CITY OF BOULDER
PLANNING BOARD MEETING AGENDA
DATE: March 3, 2016
TIME: 5 p.m.
PLACE: 1777 Broadway, Council Chambers

- B. [AGENDA TITLE: Public hearing and consideration of a Site and Use Review \(LUR2011-00071\) to redevelop the site located at 4403 Broadway Ave. with a new mixed use development.](#) The western portion of the site, zoned RM-1 (Residential – Medium 1) would include twelve 3-story townhome units divided between two buildings. The eastern portion of the site, zoned MU-2 (Mixed Use – 2), would include three new mixed use buildings containing an additional 16 attached residential units above 9,207 sq. ft. of commercial and restaurant space. The proposal includes a request for a height modification to allow for both townhome buildings and two of the mixed use buildings to exceed the 35 foot height limit for the zone (requested heights range from 36'3" to 43'6") as well as a request for a 5% parking reduction to allow for 57 parking spaces where 60 are required. The proposal also includes a Use Review request to allow for three restaurants which close after 11:00 p.m., two of which are over 1,000 sq. ft. in floor area. The applicant is seeking to create vested propert

SITE PLAN

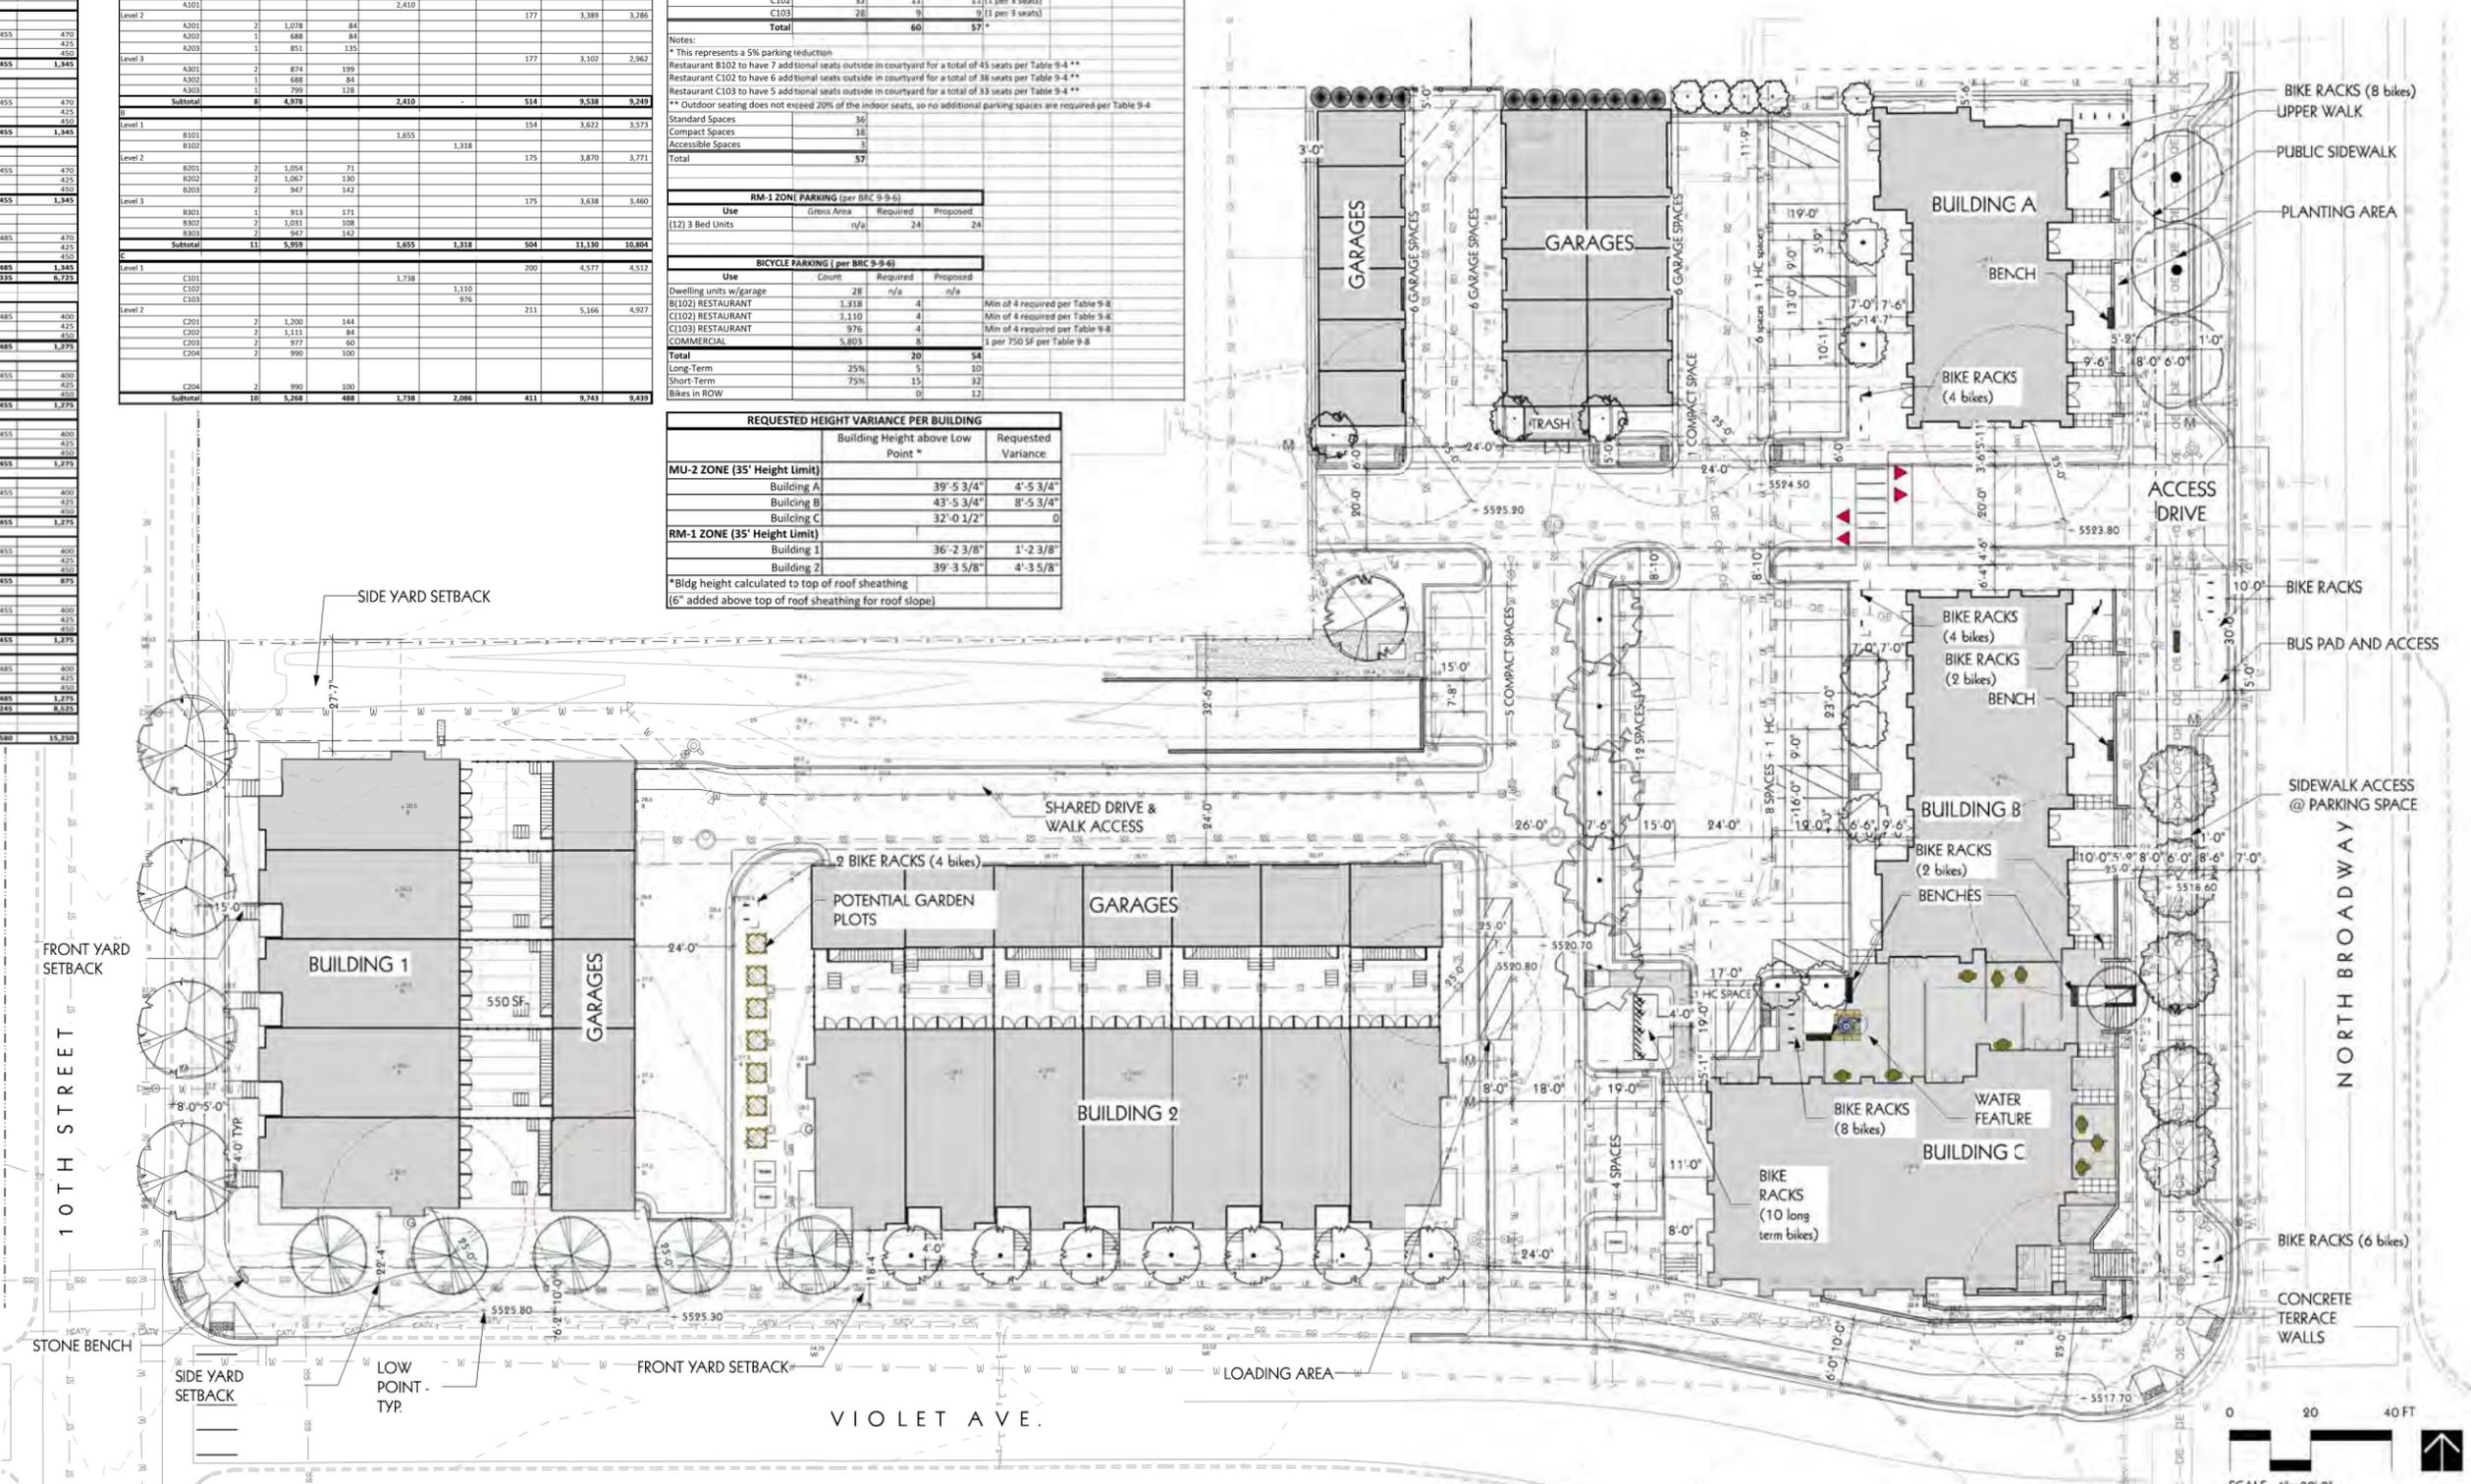
2. The Parking Tables on Sheet A1.0 appear to be incorrect. The tables list the number of spaces provided on the MU-2 portion of the property as 54 (an 18% reduction) and the number of spaces provided on the RM-1 portion as 24 (78 spaces total); however, the site plan shows 42 parking spaces on the MU-2 portion of the property (a 38% reduction) and 34 spaces on the RM-1 portion (76 spaces total). Please revise Sheet A1.0 accordingly. Staff would like to note that it is possible to request a parking reduction of up to 50% through the current process, and that only a reduction of over 50% requires approval by Planning Board through a public hearing.

3. Additional information is required for the areas labeled on Sheet A1.0 as “Parking Garage 1” and “Parking Garage 2.” If the subject areas are intended to be car ports or some other parking structure it will be necessary to provide additional detail on the site plan as well as detailed elevations of the proposed structures to demonstrate conformance with applicable form and bulk standards for accessory structures as set forth in section 9-7-1, B.R.C. 1981.

1. There are several unlabeled lines shown on Sheet A1.0 that appear to depict the locations of the existing buildings on the site. Please remove these lines.
2. The Applicant’s written statement does not address section 9-2-14(h)(2)(K), “Additional Criteria for Parking

1. Please provide clarification on the Building Summary chart shown on Sheet A1.0. Staff is assuming that the "CIRC." Column is meant to represent circulation, but it is unclear, as the areas labeled "Area counted toward FAR for egress on balcony" do not correspond with the "CIRC." numbers shown on the chart. If the 'CIRC.' Calculations are meant to represent stairways, elevators, the portions of all exterior elevated above grade corridors, balconies, and walkways that are required for primary or secondary egress, please indicate that both on the chart as well as the floor plans, and clearly call out the floor area of said areas on the floor plans. In revising the chart, please take into consideration that per section 9-16-1, B.R.C. 1981, "Floor area" is defined as "the total square footage of all levels measured to the outside surface of the exterior framing, or to the outside surface of the exterior walls if there is no exterior framing, of a building or portion thereof, which includes stairways, elevators, the portions of all exterior elevated above grade corridors, balconies, and walkways that are required for primary or secondary egress by [chapter 10-5](#), "Building Code," B.R.C. 1981, storage and mechanical rooms, whether internal or external to the structure, but excluding an atrium on the interior of a building where no floor exists, a courtyard, the stairway opening at the uppermost floor of a building, and floor area that meets the definition of uninhabitable space."

2. The setbacks labeled on Sheet A1.0 are incorrect. While front yard setbacks apply to the frontages on 10th St. and Broadway Ave. pursuant to section 9-7-2(d)(7), B.R.C. 1981, pursuant to the definition of "Yard, front, rear, and side" found in section 9-16-1, the southern property line is considered a side yard adjacent to a street and not a front yard as labeled on the plan set. In addition, the northern property line is considered an interior side yard and not a rear yard as labeled. Finally, the western property line of the northern portion of the site that abuts the neighboring property to the west is subject to RM-1 rear yard setback requirements. Please note that while it is possible to alter the setback standards through the Site Review process, following the above reinterpretation of the yard classifications for this site any modifications to the setback standards set forth in section 9-7-1, B.R.C. 1981 will require formal documentation of the additional requested variations to the land use regulations, both in the application materials as well as the plan set. Additional information on form and bulk standards can be found on-line at: http://www.colocode.com/boulder2/chapter9-7_table7-1.htm. Staff is happy to meet with the Applicant to discuss the above interpretations if there is any question as to how the interpretations were agreed upon.

6. Please revise the parking charts on Sheet SR-A1.01 to include a table showing the required and proposed number of long-term and short-term bicycle spaces. Note that the current bicycle parking standards are found in [Table 9-8](#), section 9-9-6(g), B.R.C. 1981.

OPEN SPACE DIAGRAM

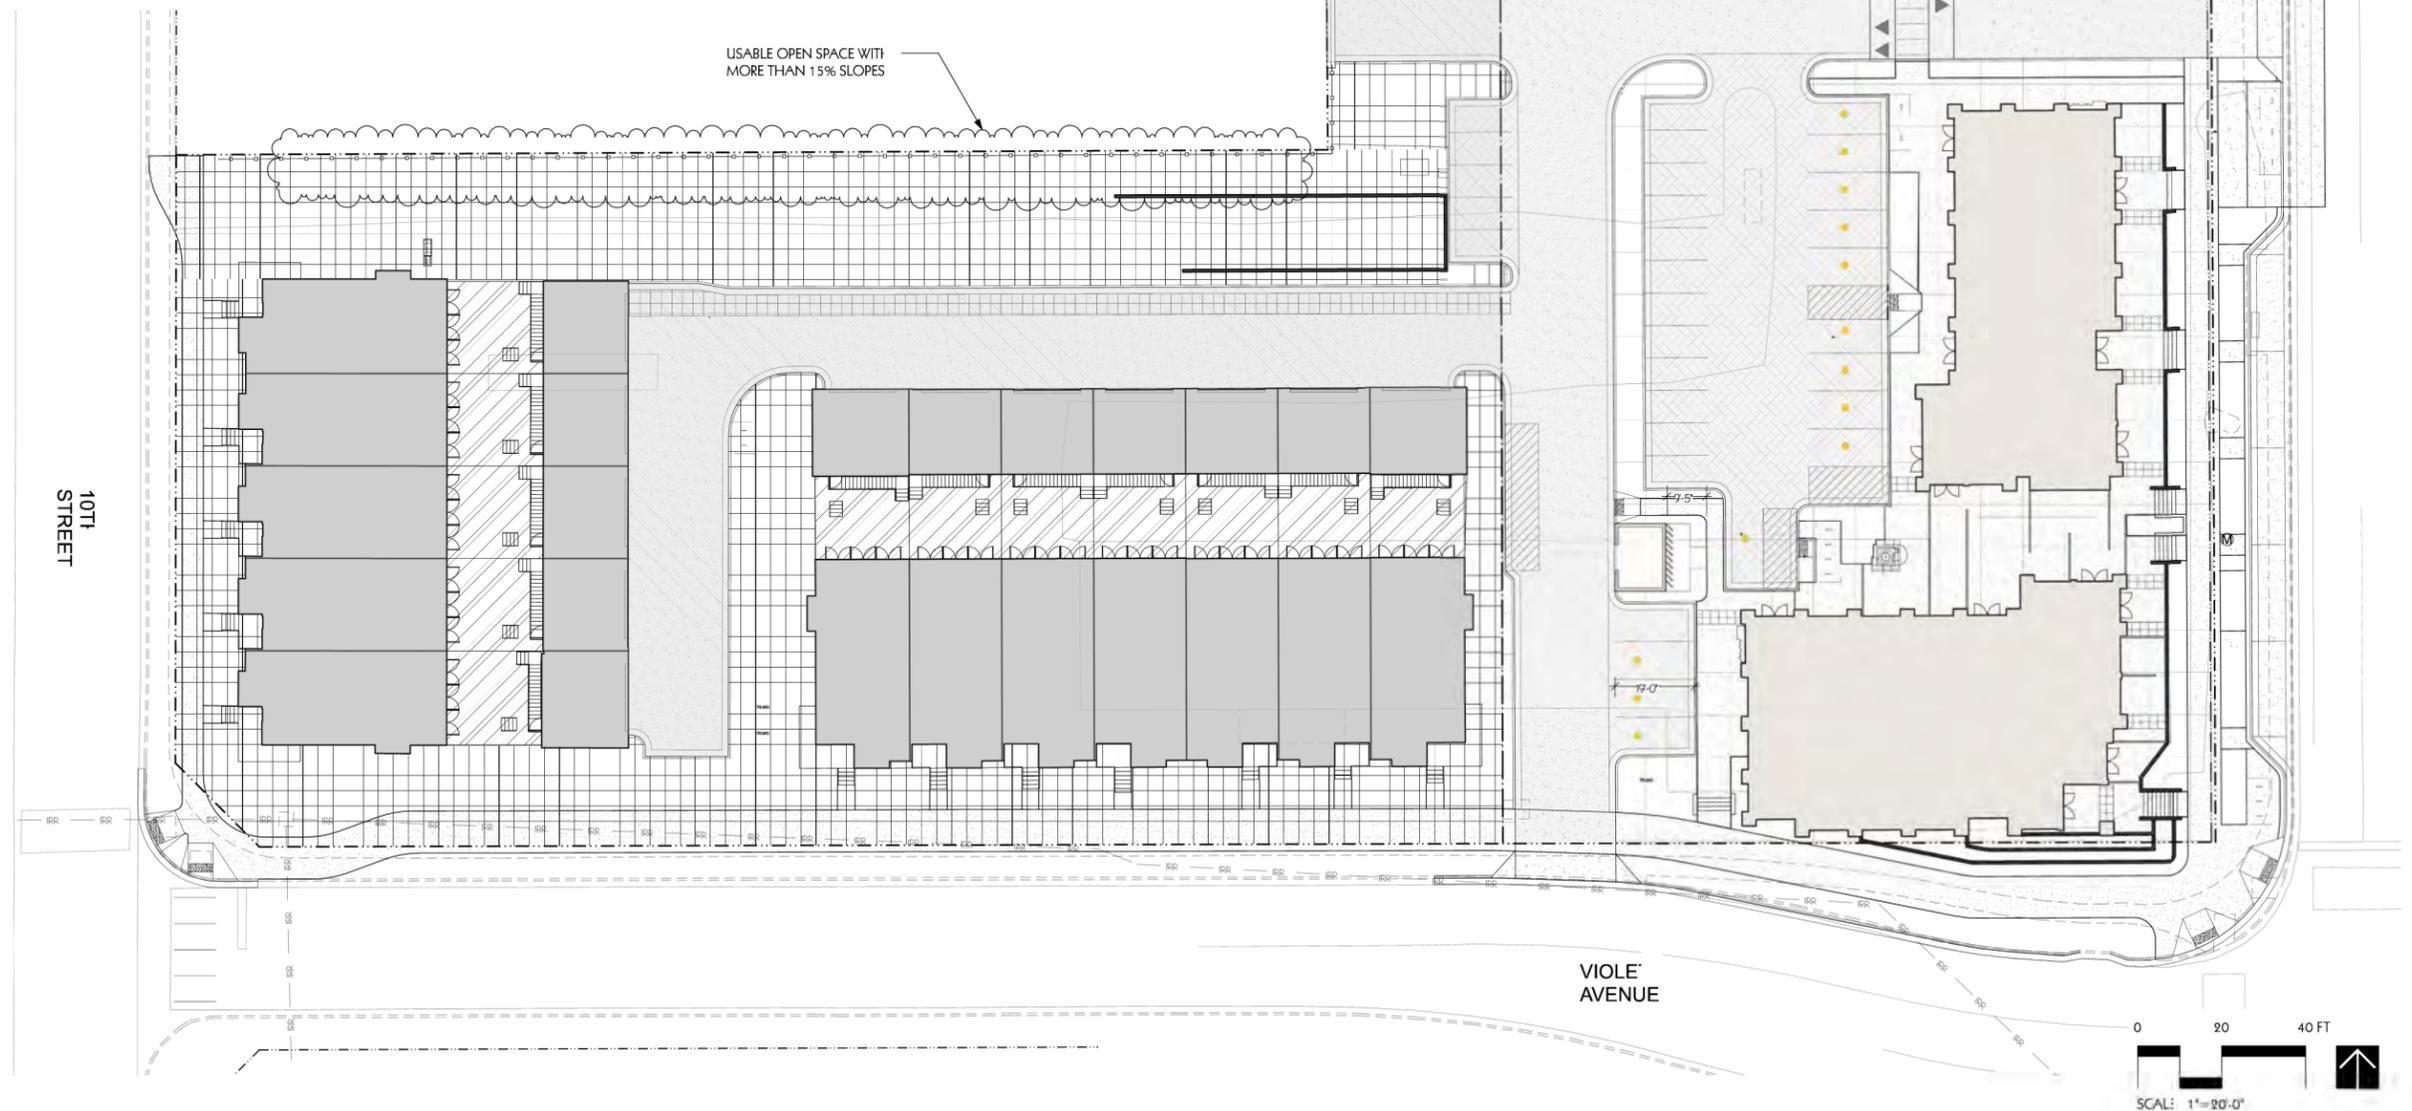
2. Additional information is needed for the open space calculations included on Sheet L2.0. Please include a full-size open space plan using color labeling and drawn to a common scale and that clearly corresponds to the open space data provided in the table. Additionally, please revise the table to include the required open space for each zone district as well as open space calculations (in square feet and percentages) for each type of open space being provided (i.e., private decks and balconies, landscaped areas, plazas/courtyards, landscaped right-of-way, etc.) as referenced in section 9-9-11, B.R.C. 1981. In revising the open space plan, please take the following comments into consideration:

- a. **RM-1 Zone:**
 - i. The "Drives and Parking" calculations and the "Buildings and Garages" calculations do not appear to correspond to Sheet A1.0. Staff's preliminary calculations indicate that the areas of the above-referenced categories are significantly larger than shown on the open space table.

3. Revise the Open Space Plan provided on Sheet SR-A1.02 to include a breakdown of the types of private open space being counted towards the 25% of the required area using the revised numbers as discussed above. The table should provide a total area for the garage decks as well as the courtyard areas and any other private decks or balconies being included. The open space diagram also has several inconsistencies which should be fixed. These include showing several individual townhouse decks as "site open space," including stairways as "private open space," and not labeling the garage decks.

TOWNHOME BUILDING 1 - ELEVATIONS

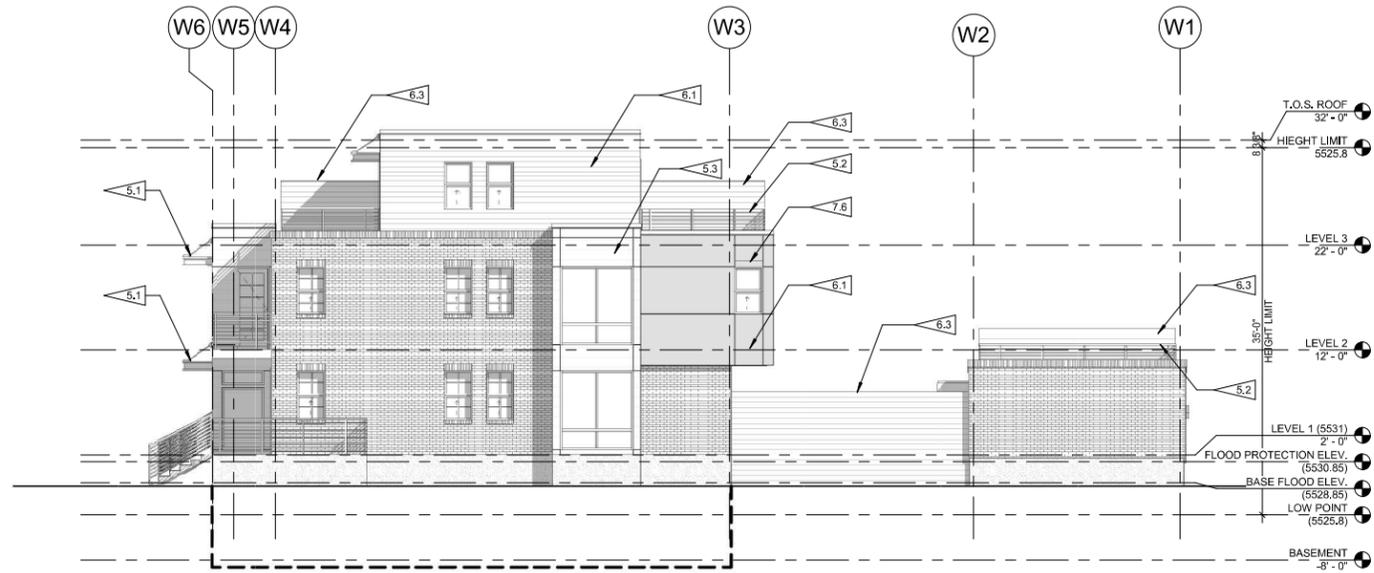
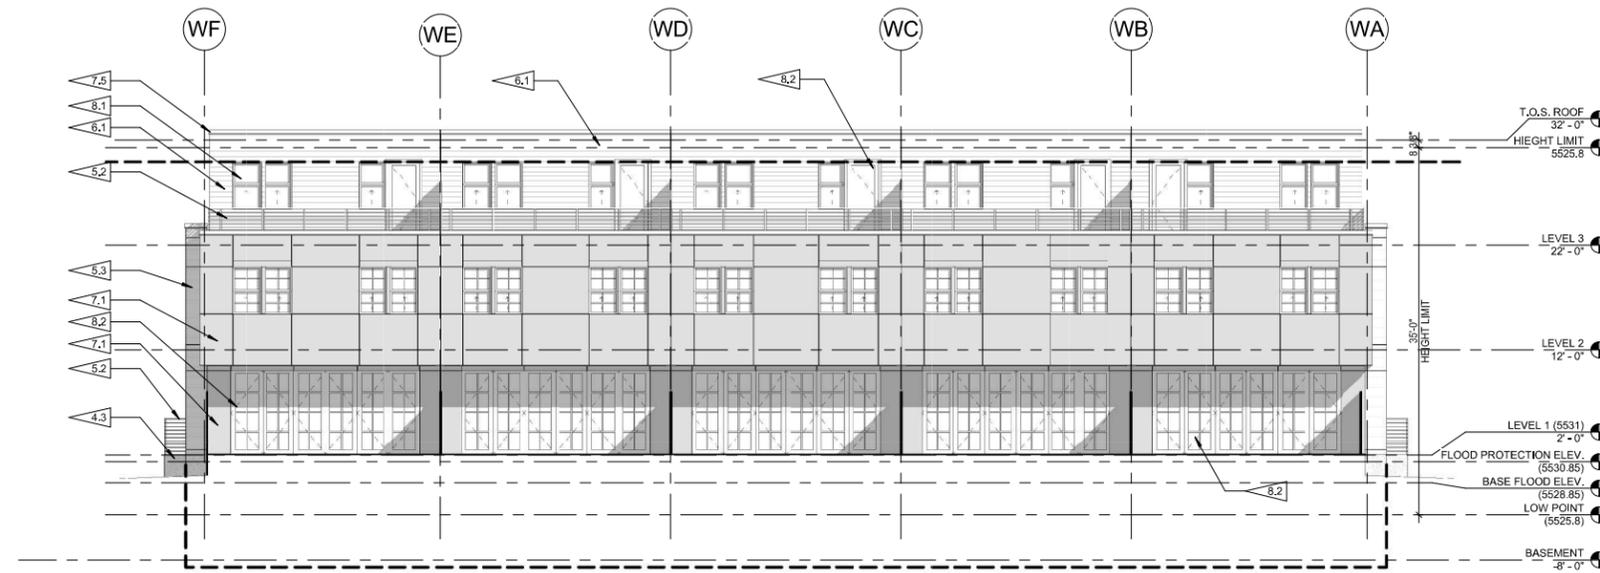
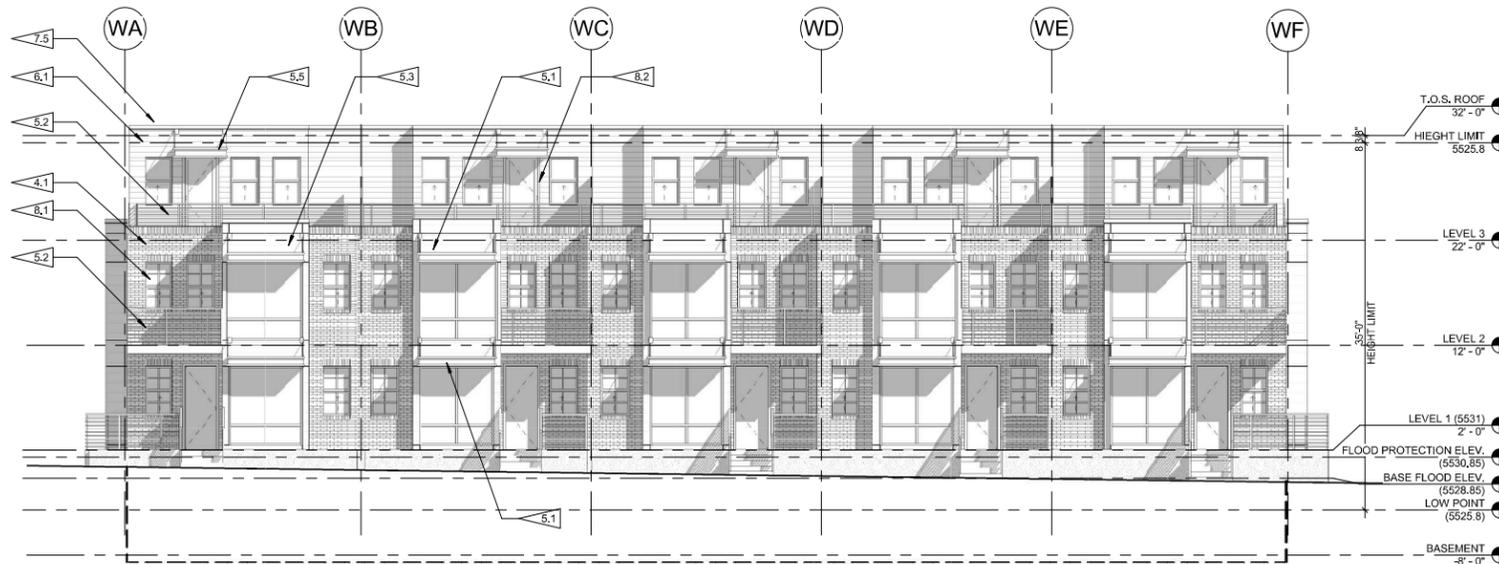
Per previous comments from city staff, all flood proofing measures, including flood vents for garages and crawl spaces should be shown on the elevation drawings for architectural review purposes. No flood vents for the garages for Building 1 are shown on the elevation drawings (Sheet SR-1-A4.01). Revise accordingly.
